**East Side Coastal Resiliency Project:
Final Scope of Work to Prepare a Draft Environmental
Impact Statement**

April 5, 2019

CEQR No: 15DPR013M

- Project Area One
- Project Area Two
- Visual Resources Study Area (400-Foot Radius)
- Photo View Direction and Reference Number

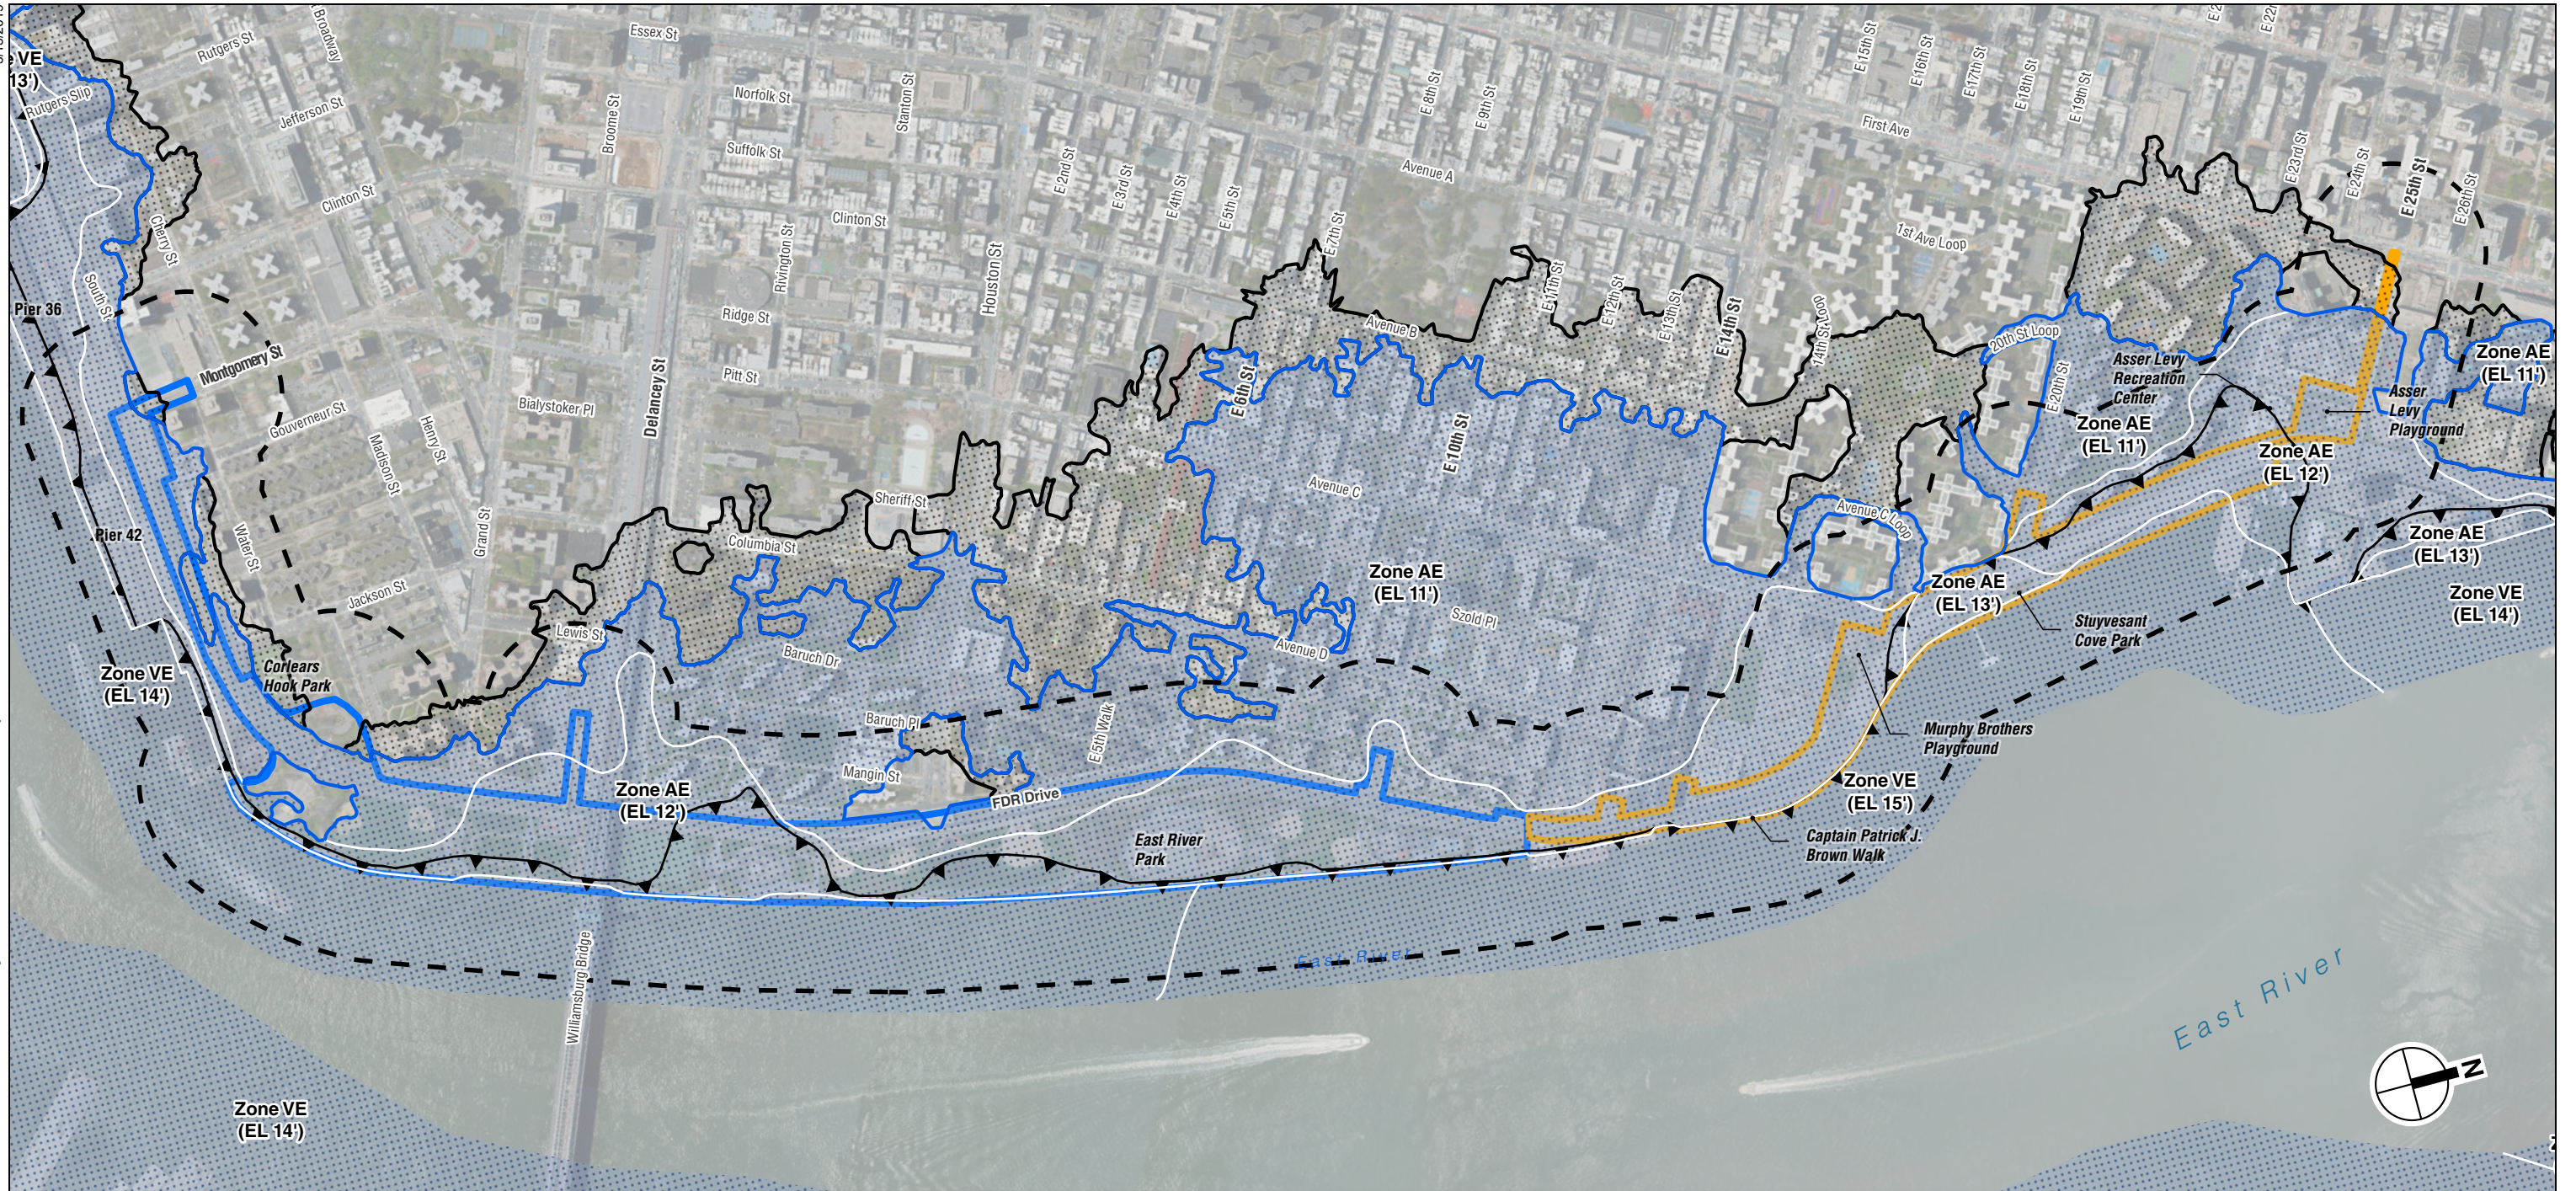
Comment 67: Correction to Figure 18: The northward Avenue C view corridor (toward the Queensboro Bridge) is an important view corridor, but here is not shown by any arrow in the drawing. I suggest that it be included and also include the direction that whatever deployables are going to be utilized are oriented so that this view corridor is preserved. (Scheyer)

Response: As described in the Draft Scope of Work, Figure 20—Urban Design and Visual Resources, Study Area and Visual Corridors—provided a preliminary identification of existing inland views to the waterfront. Figure 20 in this Final Scope of Work has been modified to include the northward view corridor from Avenue C, which will be evaluated in the EIS.
